**Town of Essex, Vermont**  
**Application for Zoning Permit**  
 www.essex.org

**TOWN OF ESSEX, VERMONT  
APPLICATION FOR CURB CUT / UTILITY PERMIT**

“Subdivision Plat Joseph Bibeau and Sandra Wright 19 Lost Nation Road Essex, Vt.” as drawn by Trudell Consulting Engineers, dated 1/15/09, last revised 2/25/09; and

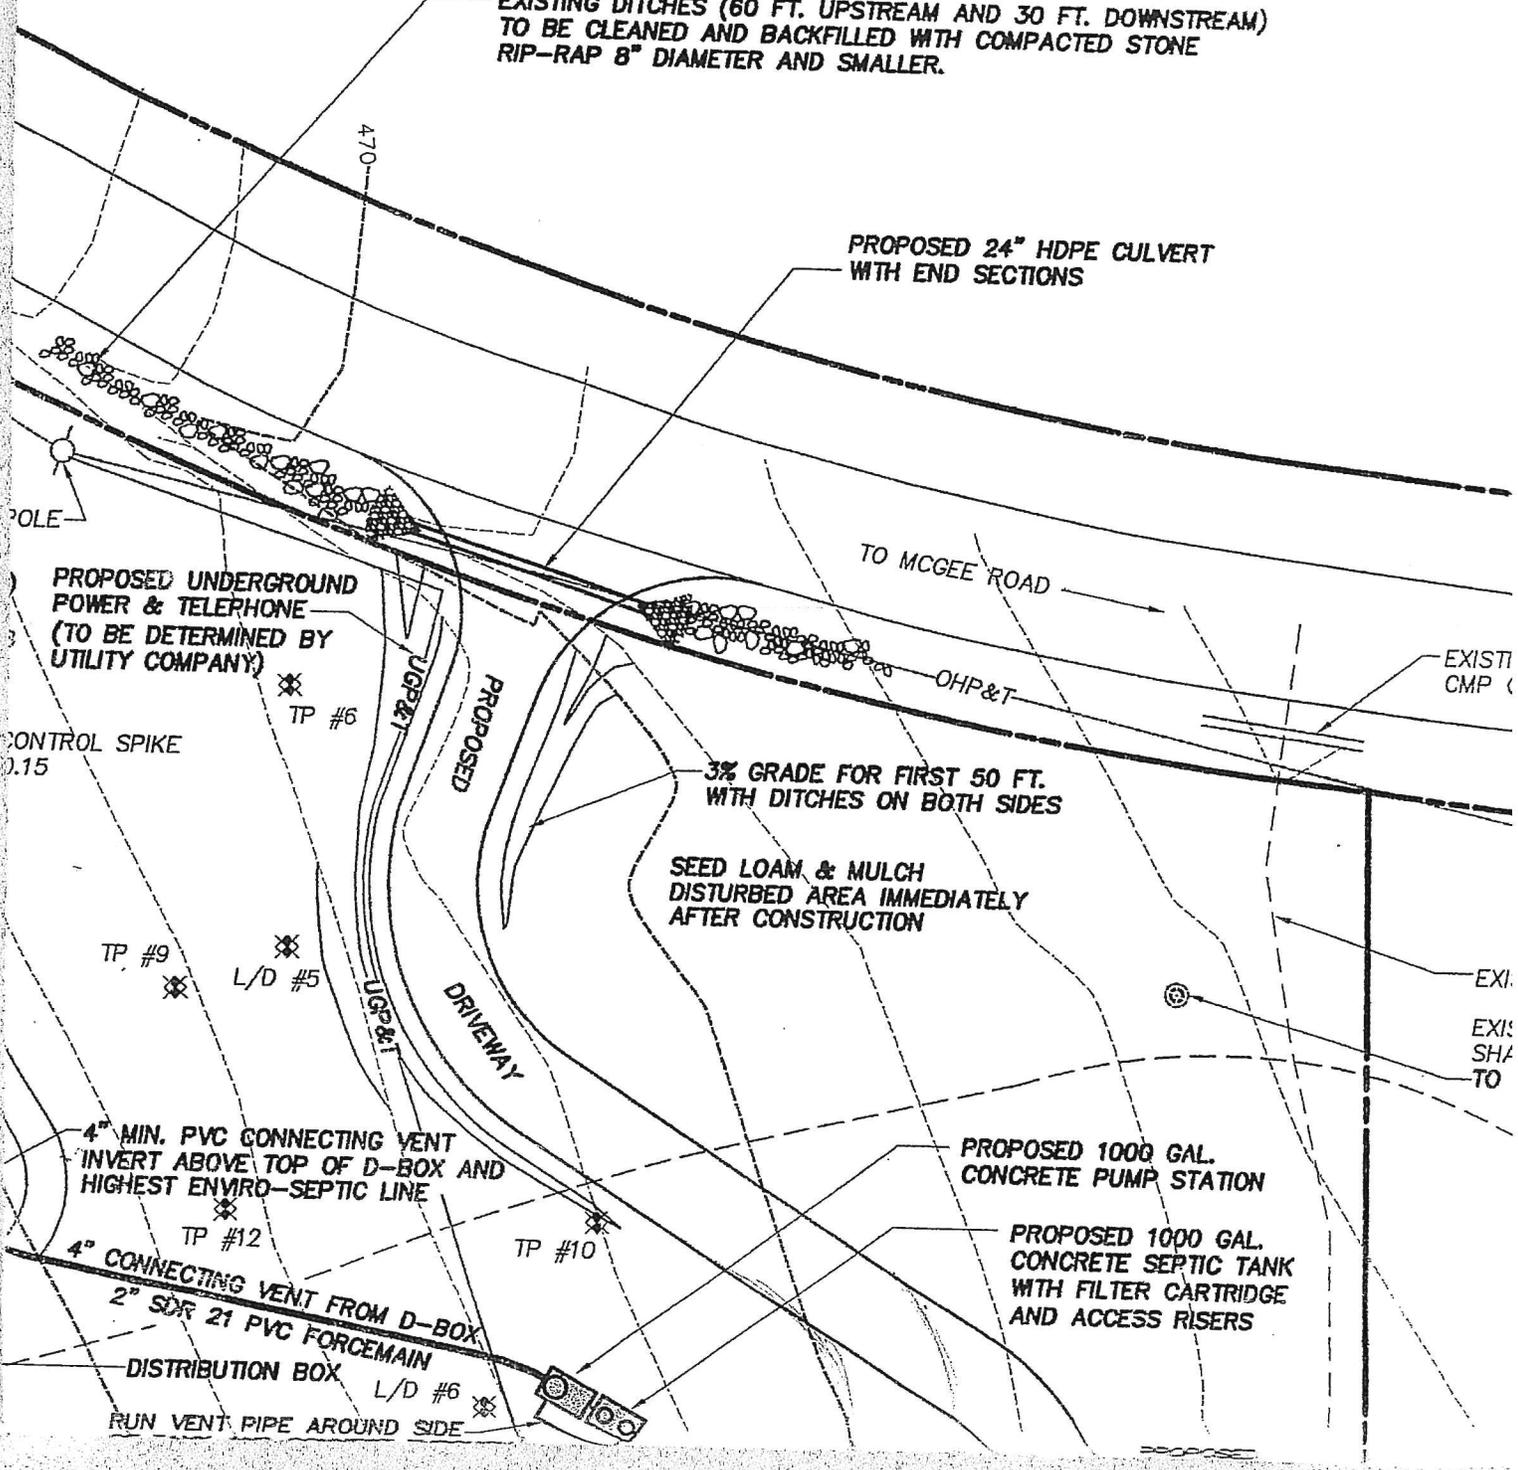
Comments be Director of Public Works / Town Engineer:

Culvert : Yes  No  Water Bar(s) : Yes  No

Culvert Diameter: (18 inch minimum) 24" Total length of Culvert: (30 foot minimum) 30'

1. Culvert must be HIGH DENSITY POLYETHYLENE (HDPE) PIPE
2. Culvert will be purchased by the Applicant  
Culvert will be purchased and installed by the applicant. The Town of Essex Department of Public Works will inspect.
- 3.

EXISTING DITCHES (60 FT. UPSTREAM AND 30 FT. DOWNSTREAM)  
TO BE CLEANED AND BACKFILLED WITH COMPACTED STONE  
RIP-RAP 8" DIAMETER AND SMALLER.

PROPOSED 24" HDPE CULVERT  
WITH END SECTIONS
